Sundry Print Reports
10/07/2022

Well Name: ARKENSTONE 31 Well Location: T23S / R31E / SEC 31 / County or Parish/State: EDDY /

**Sundry ID: 2680048**

Type of Action: APD Change

WELL LOCATION AND ACREAGE DEDICATION PLAT

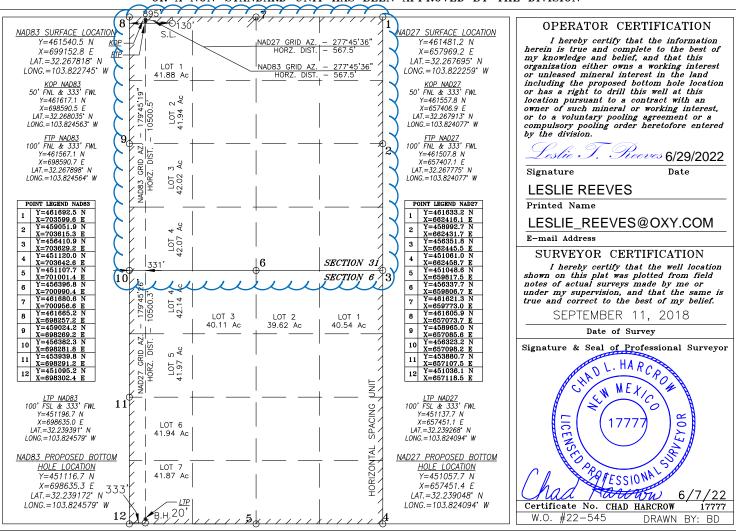
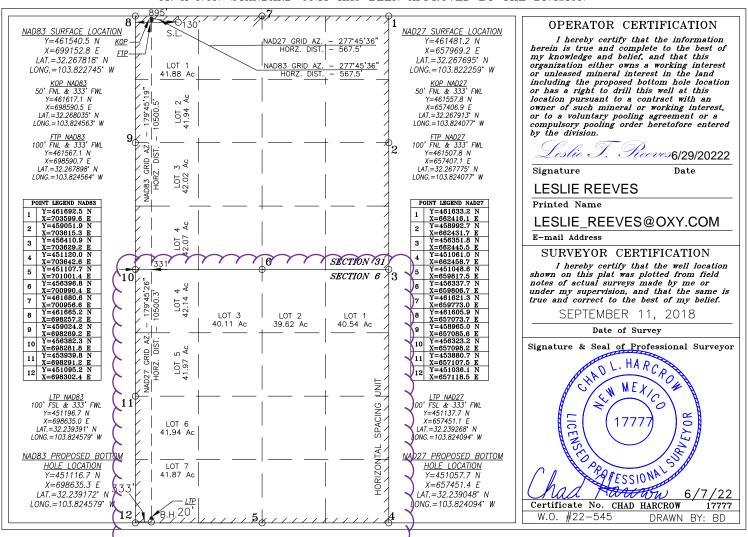
**Procedure Description:** OXY USA Inc. respectfully requests approval to amend the subject well AAPD BHL, change the pool to the two noted wolfcamp pools, amend the HSU, and update the drilling plans (casing, cementing, mud programs). The updated well plats, drill plan and directional are attached. The surface hole is not changing. Old BHL: 20' FSL 430' FWL M-31-23S-31E New BHL: 20' FSL 333'FWL M-6-24S-31E

TOTAL DEDICTION I BIT				
API Number	Pool Code	Pool Name				
30-015-46370	98220	PURPLE SAGE WOLFCAMP	(GAS)			
Property Code	Prop	Property Name				
326150	ARKENSTON	ARKENSTONE 31 FEDERAL				
OGRID No.	Oper	ator Name	Elevation			
16696	OXY	OXY USA INC.

UL or lot No.	Section	Townshi	ip	Range	Lot Idn	Feet from the	North/South line	Feet from the	East/West line	County
7	6	24-5	S	31-E		20	SOUTH	333	WEST	EDDY
Dedicated Acres	Joint o	r Infill	Con	solidation (	Code Or	der No.				
648.19
